METROPOLITAN GOVERNMENT OF NASHVILLE AND DAVIDSON COUNTY

STAFF RECOMMENDATION
405 Chapel Avenue
March 21, 2012

Application: Infill and Demolition
District: Eastwood Neighborhood Conservation Zoning Overlay
Council District: 06
Map and Parcel Number: 08302011100
Applicant: Mitch Hodge, AIA
Project Lead: Robin Zeigler, robin.zeigler@nashville.gov

<p>Description of Project: Applicant proposes to demolish the non-contributing house at 405 Chapel and construct a new single-family home.</p> <p>Recommendation Summary: Staff recommends approval of infill construction at 405 Chapel Avenue with the conditions that:</p> <ol style="list-style-type: none"> 1. The upper level be redesigned to match the context in terms of form; 2. The driveway be a strip driveway at least to the front wall of the house; 3. Final design for materials be approved by staff; and 4. A window be added to the ground floor on the right side. <p>With these conditions, staff finds that the project meets the design guidelines for the Eastwood Neighborhood Conservation Zoning Overlay.</p>	<p>Attachments A: Photographs B: Site Plan C: Elevations</p>
---	--

CONTEXT

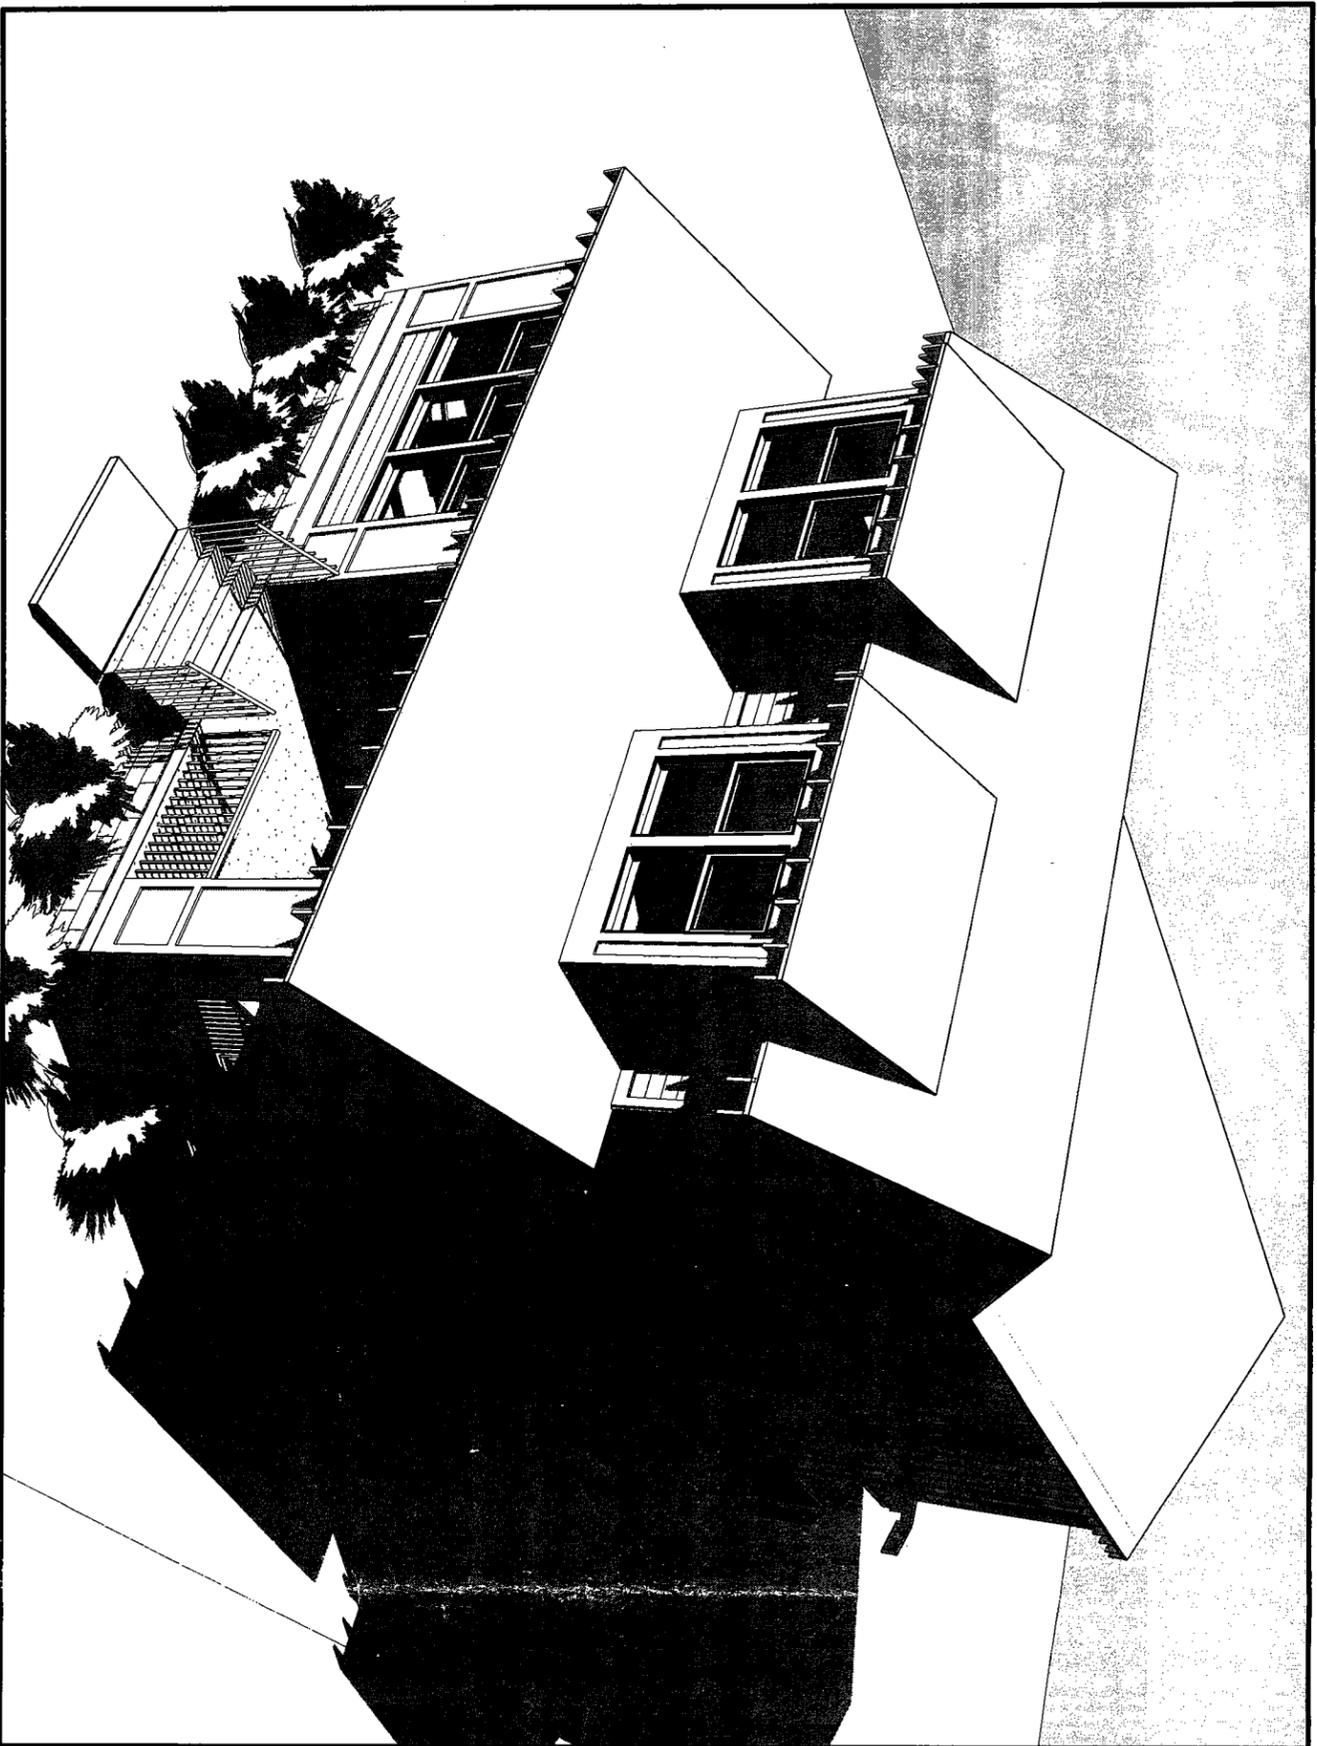
The houses to either side of this lot are non-contributing.

The corner of Chapel and Sharpe Avenues provides some historic context for homes taller than what is found immediately surrounding 405 Chapel.

1 SITE PLAN
 SD-1 1" = 20' 0"

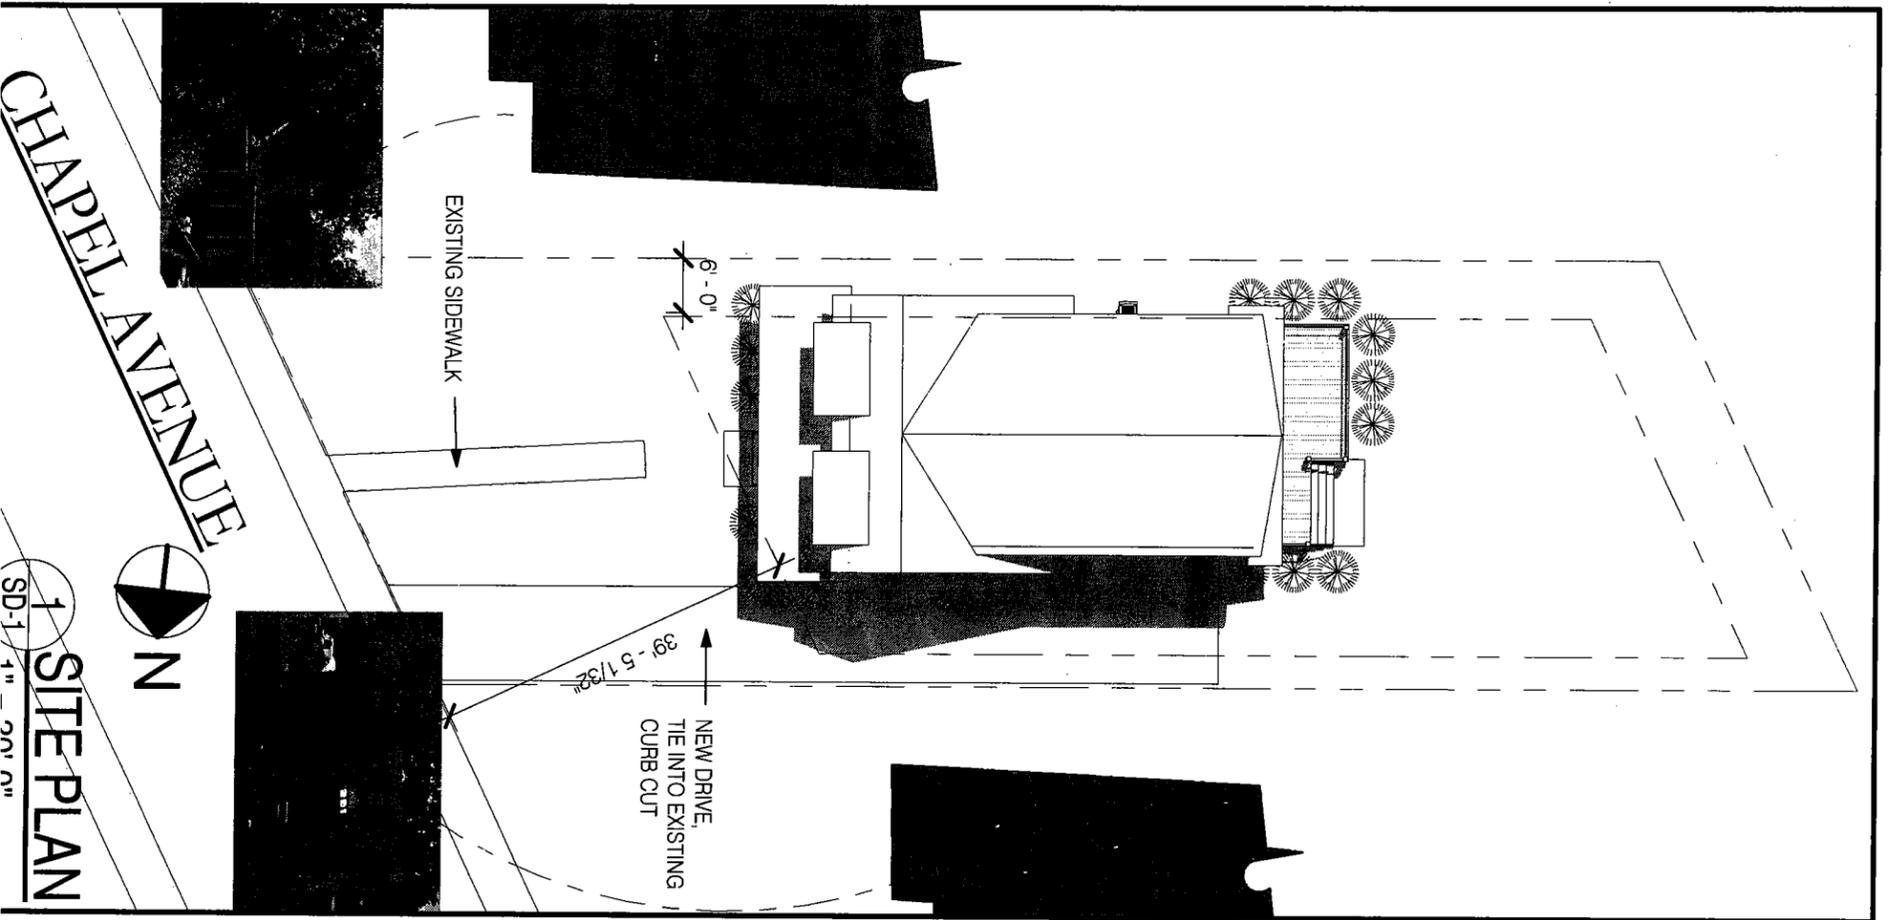
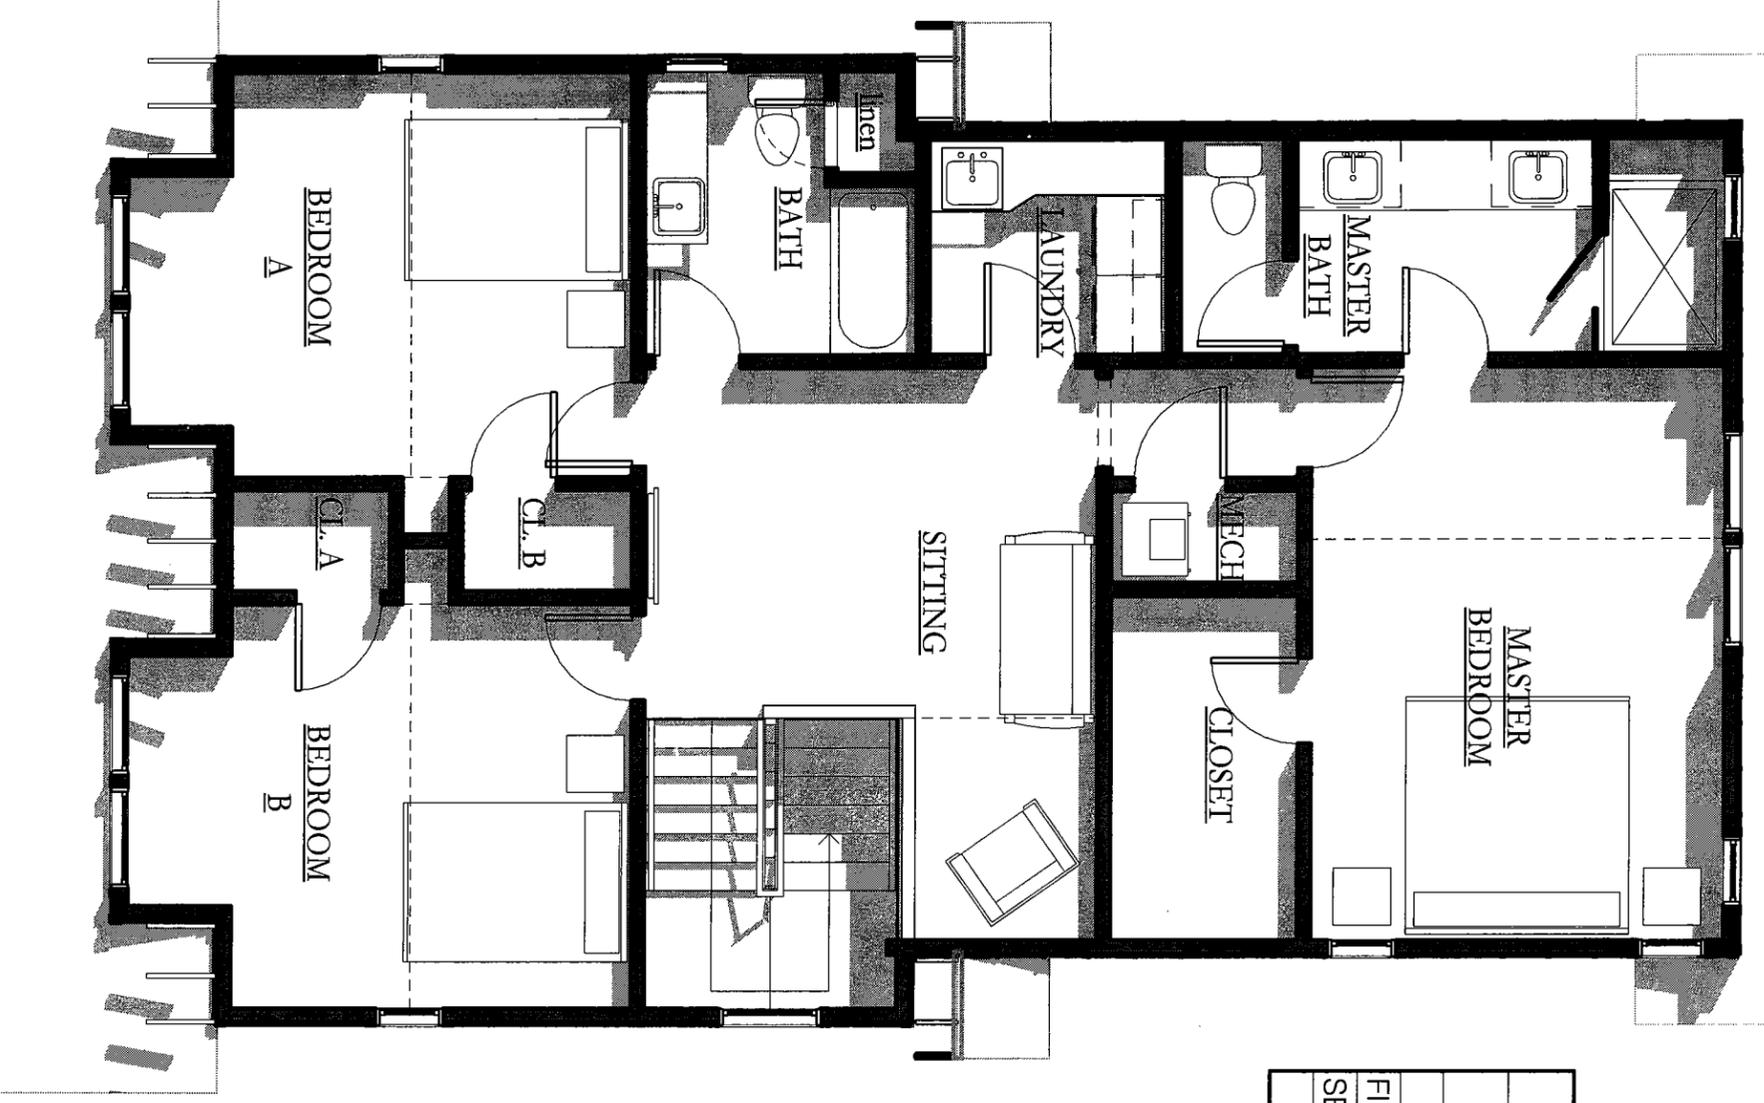
The side and rear setbacks meet bulk zoning. The front setback is varied due to the angled street and the house sits within the saw tooth line created by the existing homes on either side. Although these homes are not historic, there are many historic homes along Chapel that follow this pattern.

The proposed house is positioned to the left of the lot to accommodate a right side driveway, many of which exist in the immediate context. In addition, there is no alley for vehicular access. The project meets the design guideline II.B.1.c in terms of setback and rhythm of spacing.

Staff recommends a strip driveway at least to the front wall of the house, after which the drive could be solid and final approval of material details. With this alteration, the materials meet section II.B.1.d.

5. The upper level be redesigned to match the context in terms of form;
6. The driveway be a strip driveway at least to the front wall of the house;
7. Final design for materials be approved by staff; and
8. A window be added to the ground floor on the right side.
